BYLAW C-7991-2020

A Bylaw of Rocky View County, **in the Province of Alberta, to adopt** the Ascension Conceptual Scheme

SCHEDULE 'A'
FORMING PART OF BYLAW C-7991-2020

A Conceptual Scheme affecting Block 6, Plan 8710757, NE-18-25-2-W5M; Block A, Plan 9212196, SE-19-25-2-W5M; a portion of SE-19-25-2-W5M; and SW-19-25-2-W5M, herein referred to as the Ascension Conceptual Scheme.

Figure 2 - Regional Residential Context

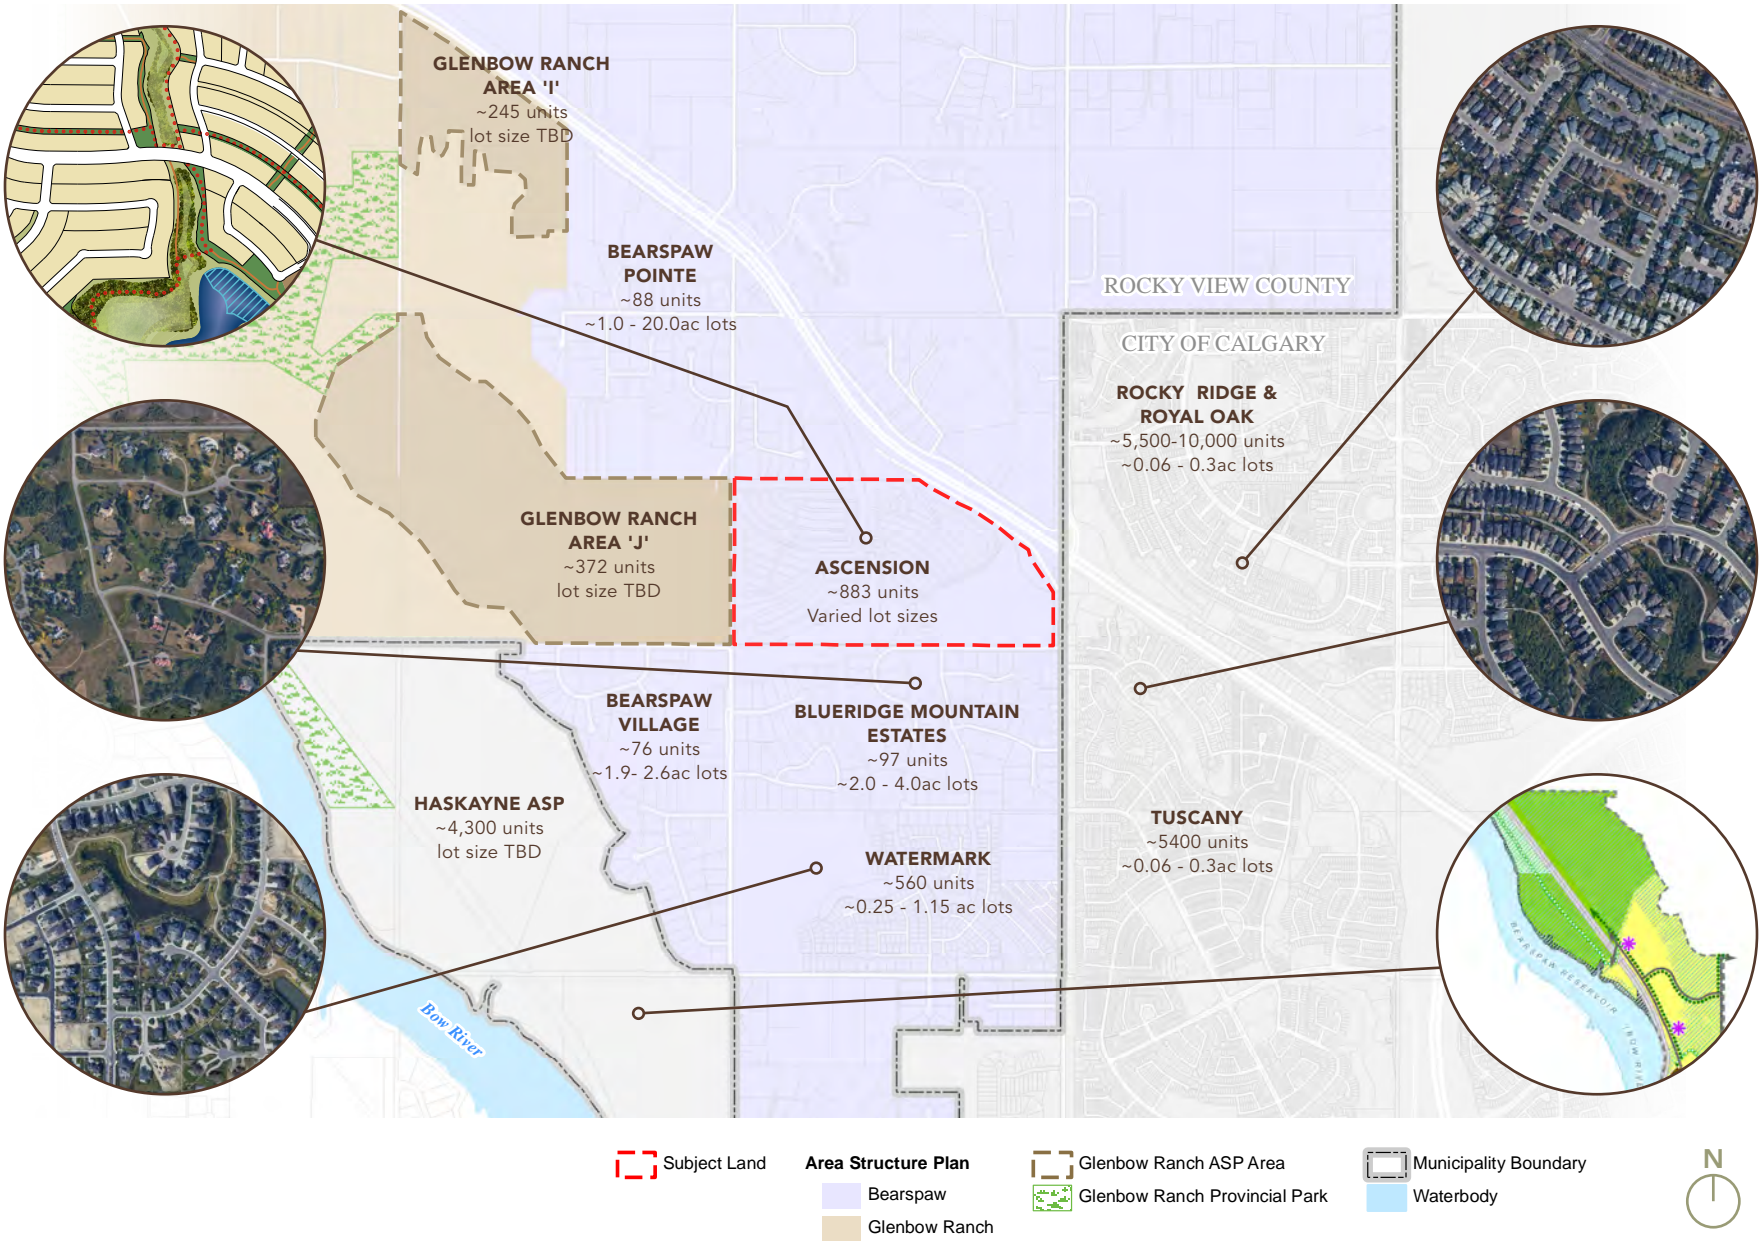
New Figure, significantly updated from former Figure 1

Figure 7 - Titled Ownership Parcels

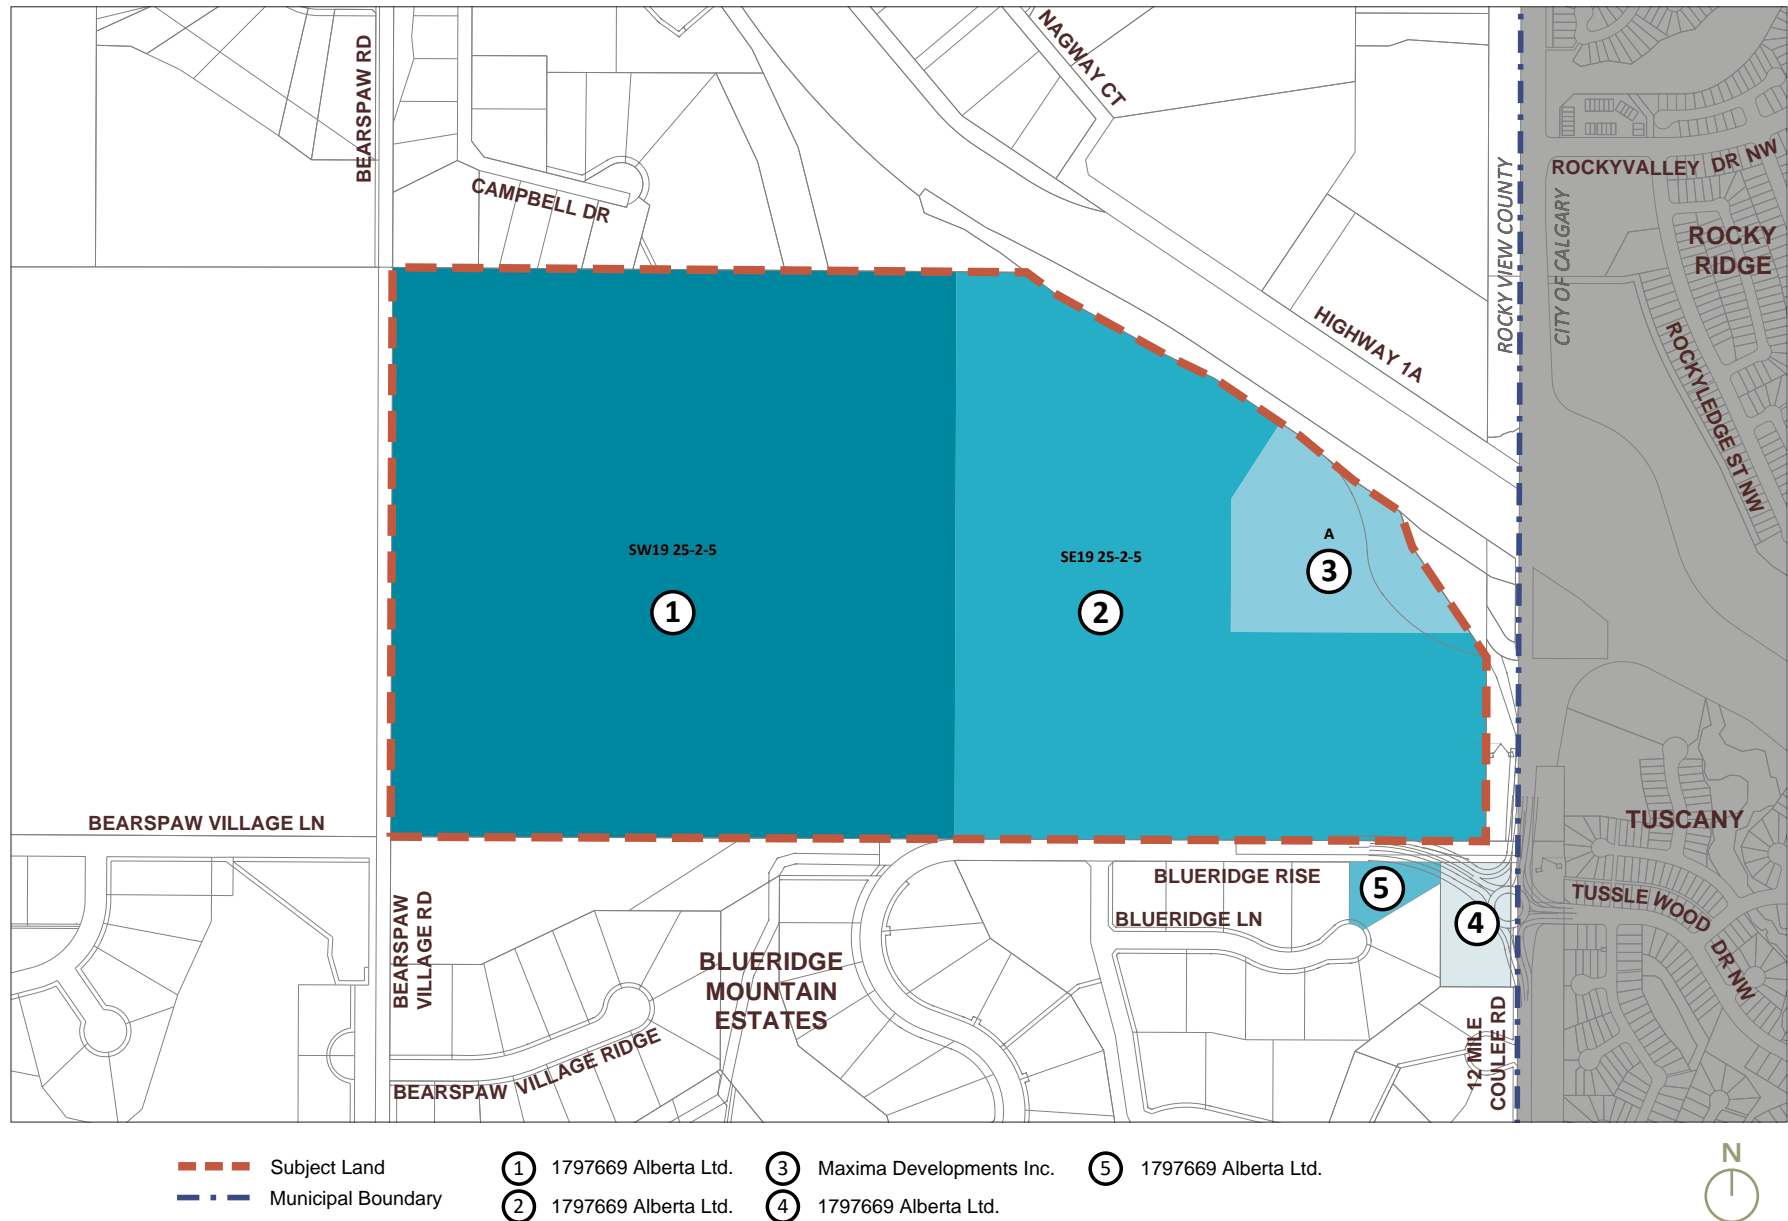
Formerly Figure 3 - Figure was updated

Figure 8 - Existing Site Conditions

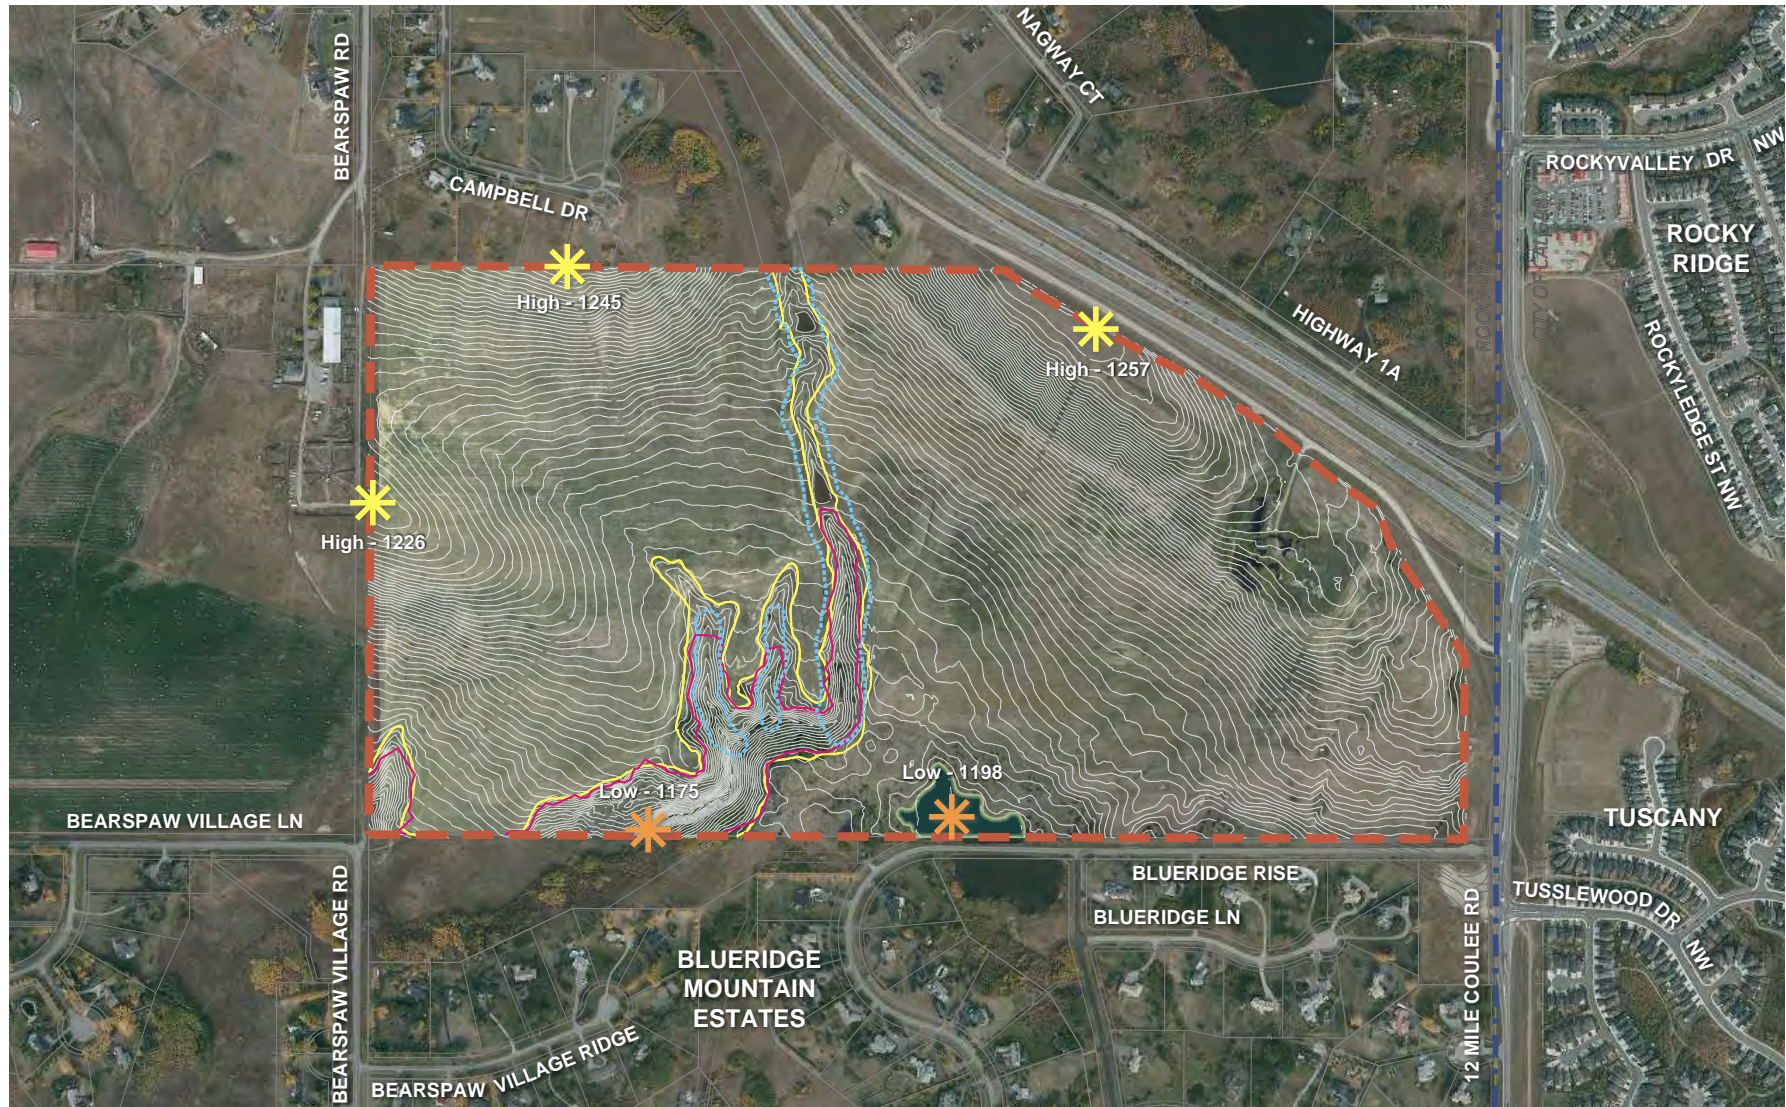
Formerly Figure 4 - Figure was updated

Figure 12 - Boundary Interfaces

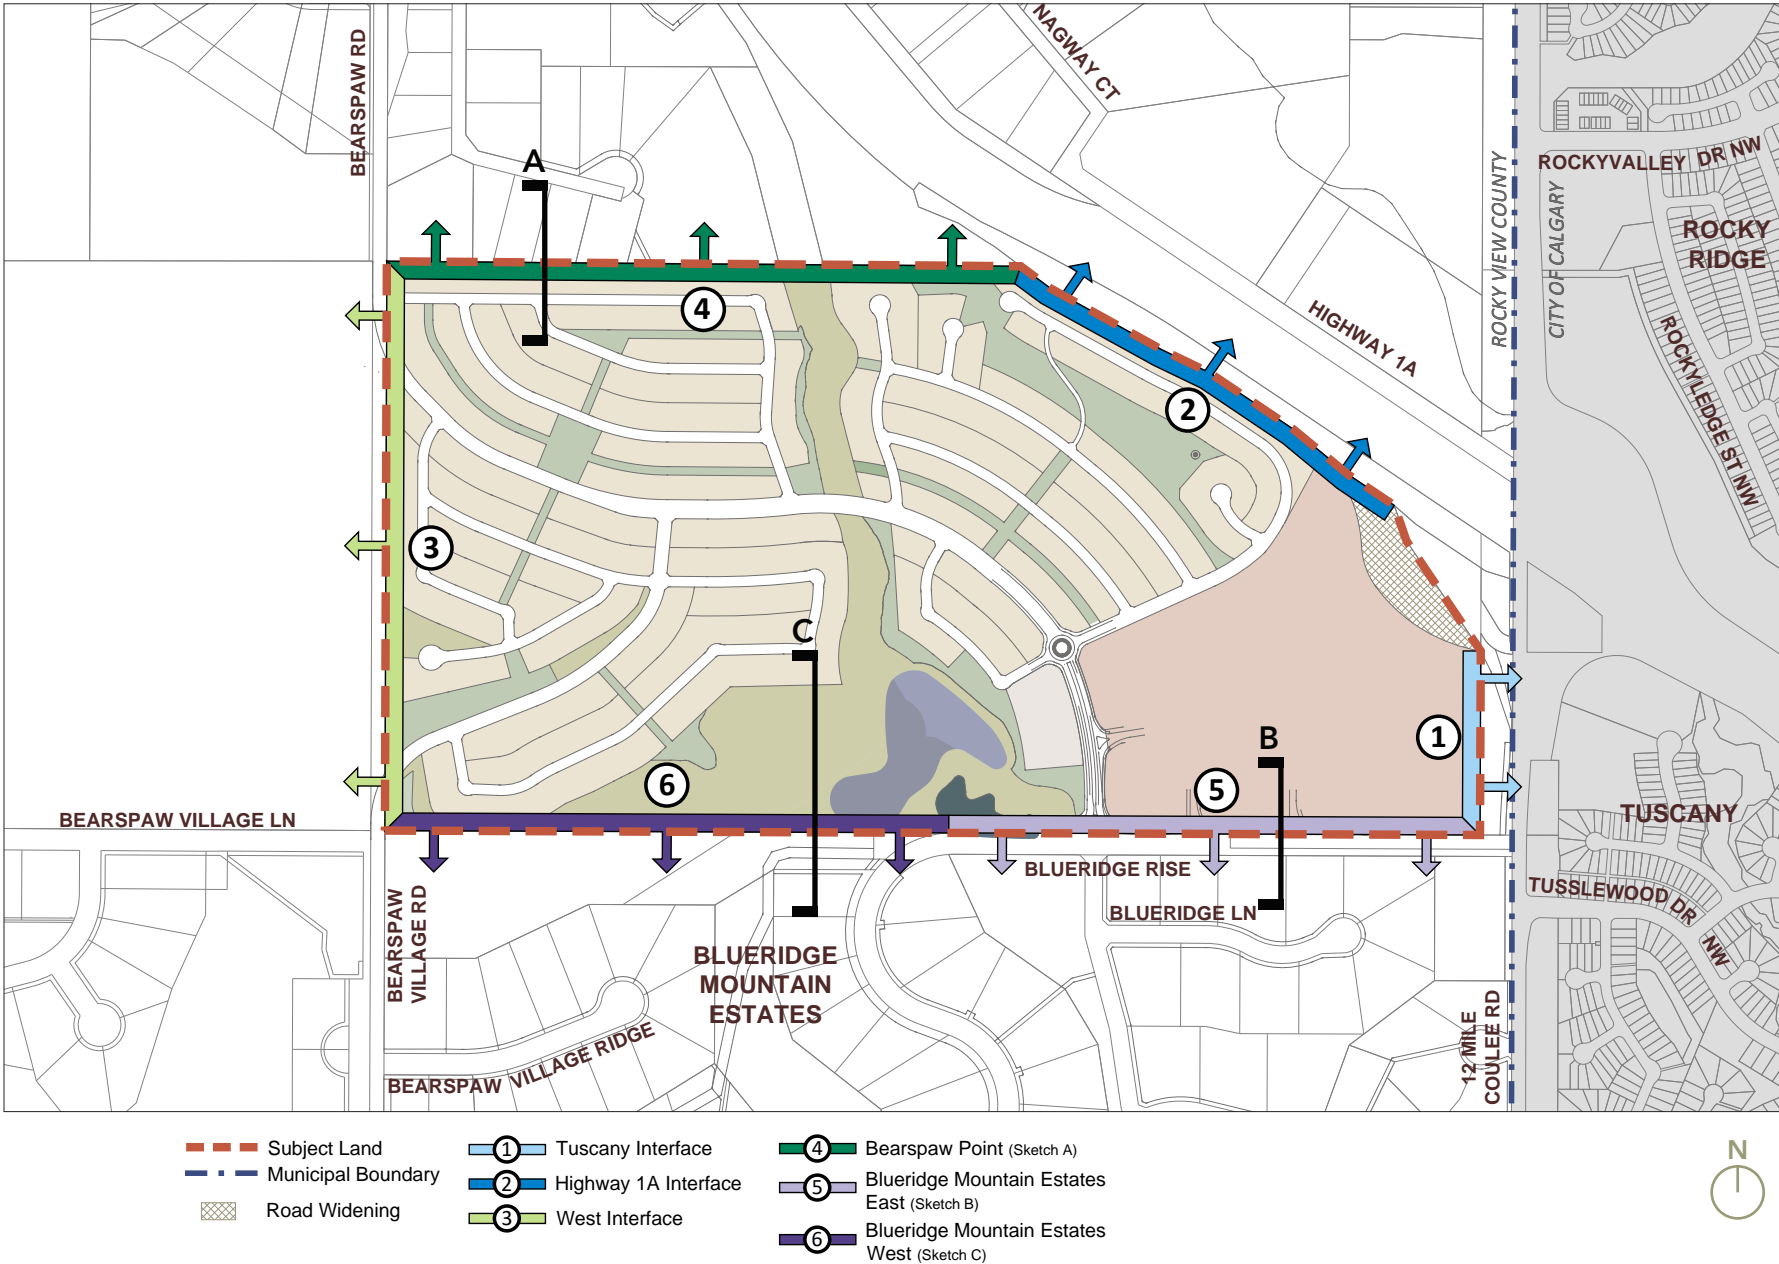
Figure was updated

Figure 13 - Regional Transportation Plan

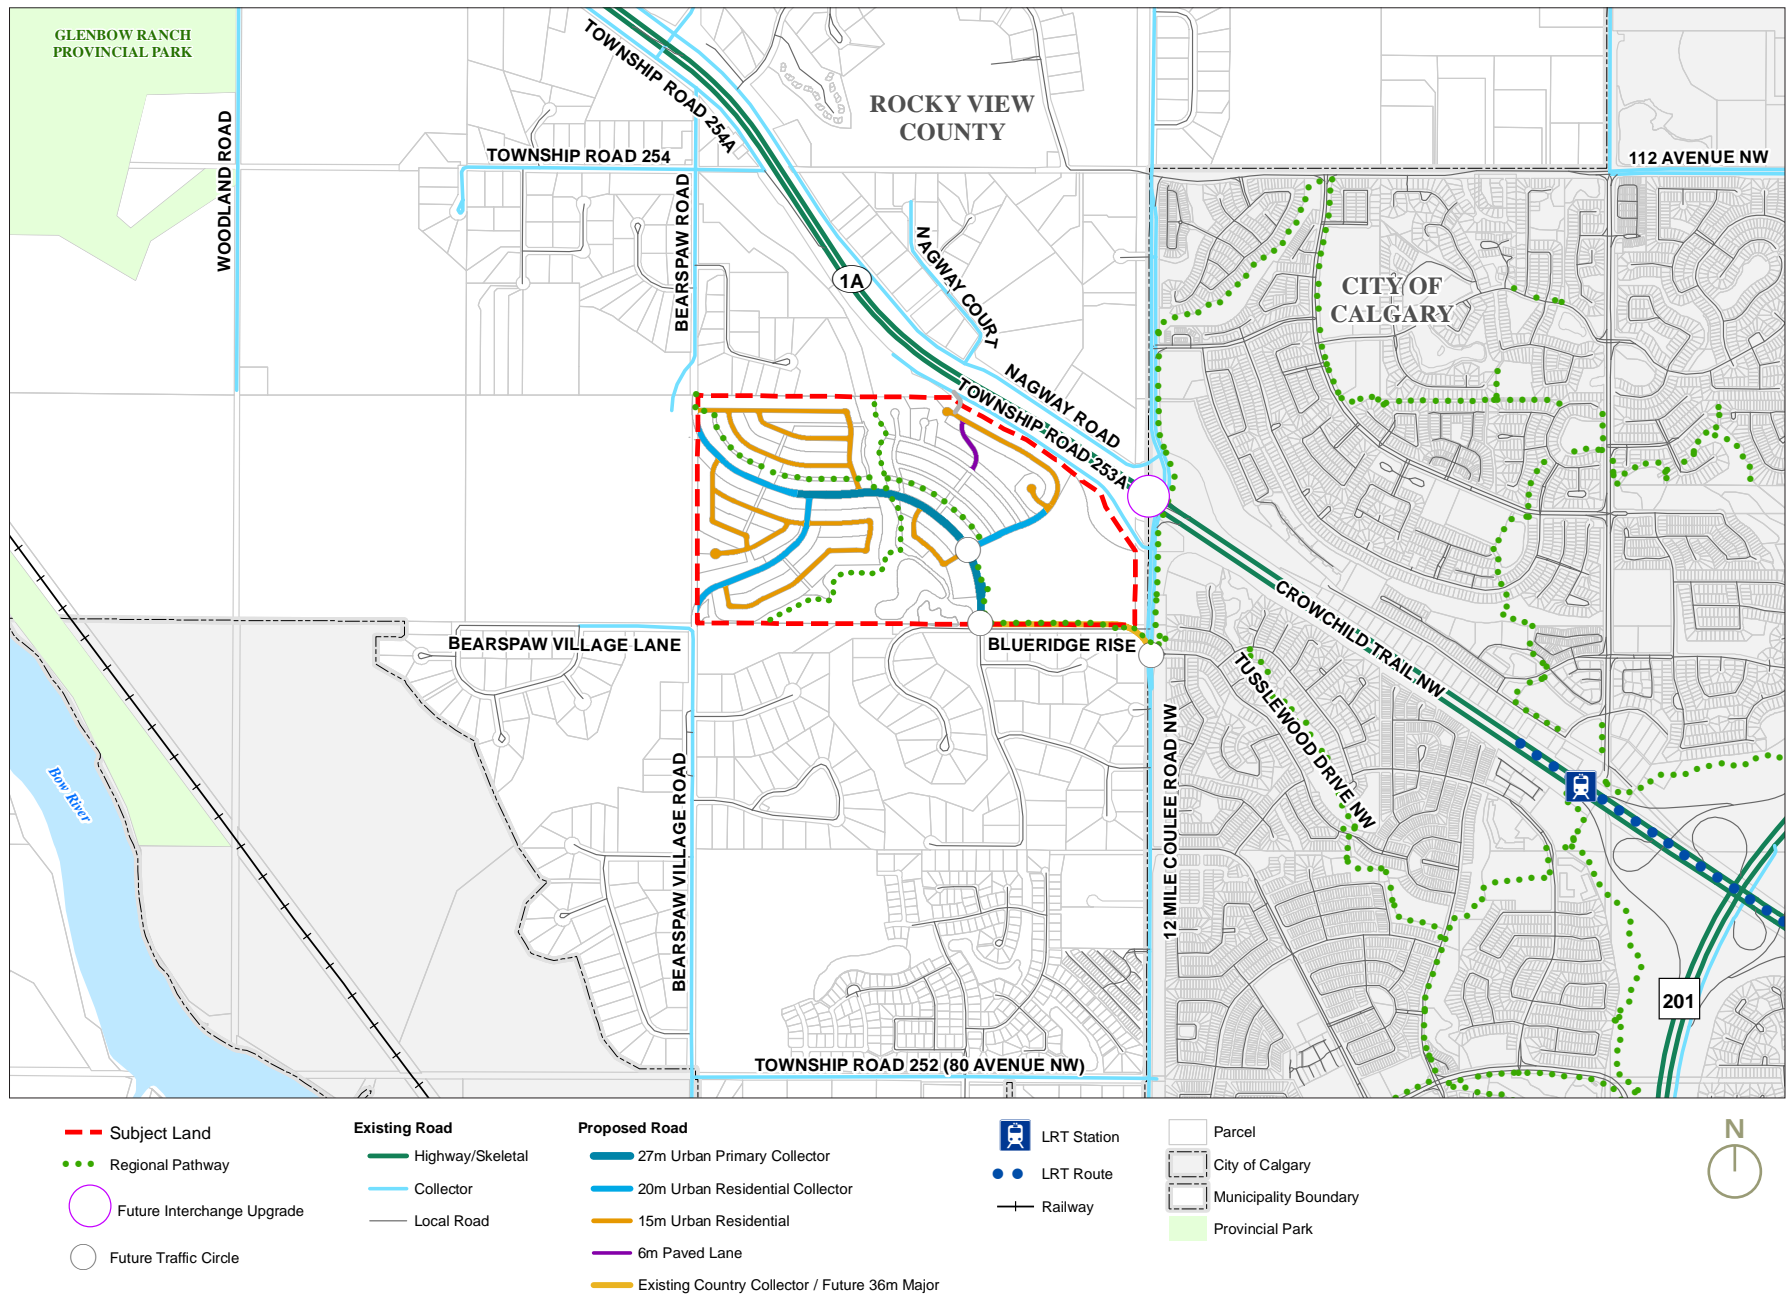
Figure was updated
